Subject: The Los Angeles Department of Water and Power's Mono Basin Feasibility Report In Response to the Stream Scientists' Final "*Synthesis of Instream Flow Recommendations to the State Water Resources Control Board and the Los Angeles Department of Water and Power, Final Report*",
Reference: GSB 1631

MONO BASIN FEASIBILITY REPORT

In Response to the Stream Scientists'
"Synthesis of Instream Flow Recommendations"
(Synthesis Report)
to
The State Water Resources Control Board
and
The Los Angeles Department of Water and Power,
of April 30, 2010

JULY 28, 2010
LOS ANGELES DEPARTMENT OF WATER AND POWER

Figure 1: Sample Feasible Hydrograph

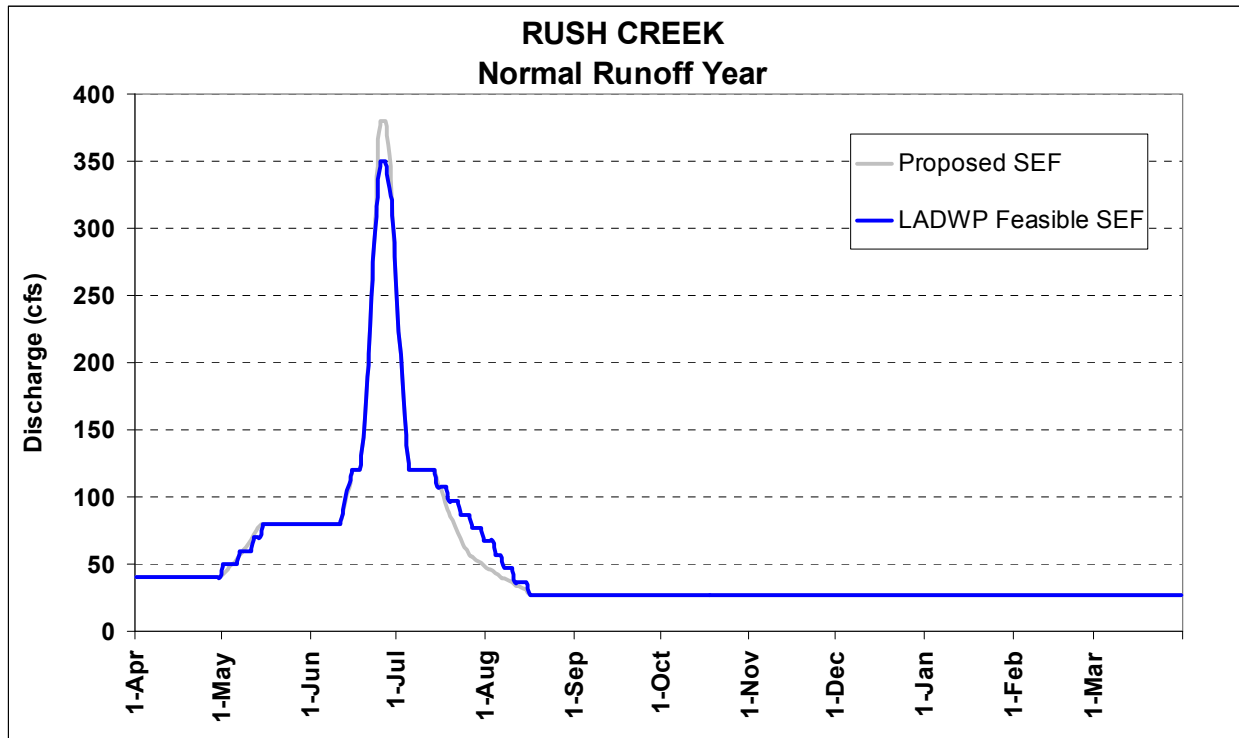
Stream Scientists' Recommendation – Stream Scientists have stated that the recommended hydrographs are templates and not the final recommended annual hydrographs. They noted that small-magnitude (such as 3 percent to 6 percent) hydrograph transitions in the Rush Creek SEF cannot necessarily be reproduced in LADWP releases.

Analysis – Small daily flow rate releases such as 3 to 6 percent are unreasonable and operationally not feasible. The Stream Scientists have indicated that the recommended annual hydrographs for Rush Creek must be considered templates and have acknowledged that small-magnitude hydrograph transitions can not all be feasibly reproduced.

LADWP can feasibly operate water releases to lower Rush Creek from Grant Lake using a minimum increment of 10 cubic feet per second (cfs) or 10 percent, whichever is greater. The eight foot gate used to operate release flows from Grant Lake is not suited for small changes in flows. Once the gate is moved during a flow change, the gate must be reseated, and the reseating of the gate by itself can change flows by a few cfs. Also, the method of determining flows can have a margin of error up to a few cfs, again causing problems with achieving a specific flow down MGORD. With very small flow changes, trying to unseat a massive gate, move it slightly, reseat it, and then wait several hours for the flows to travel to MGORD, all in an environment where flow measurement error is greater than the actual flow change, is impractical, especially in light of the inability to define the ecological implications of a given small flow difference (such as between 35 and 41 cfs, for instance).

In lieu of the 3 percent to 6 percent small rate of change specified by the SEFs, LADWP proposes keeping the smallest existing ramping rate as prescribed in Order 98-05, which is 10 cfs or 10 percent, whichever is greater. Flow changes of a minimum of 10 cfs increments are the smallest that can practicably be made to the MGORD in a reliable and operationally reasonable fashion. A sample hydrograph with LADWP feasible 10 cfs/10 percent ramping is shown below in Figure 1 for a Normal year type. LADWP would like to note that the recommended new SEFs will require more flow changes than currently done due to more ascension and recession nodes in the hydrographs as well as specific time periods the flow changes have to be made. This would entail more manpower and wear and tear on the outlet gate, potentially resulting in increased maintenance needs.

Note: Maximum peak of “LADWP Feasible SEF” is 350 cfs because of MGORD capacity limitation
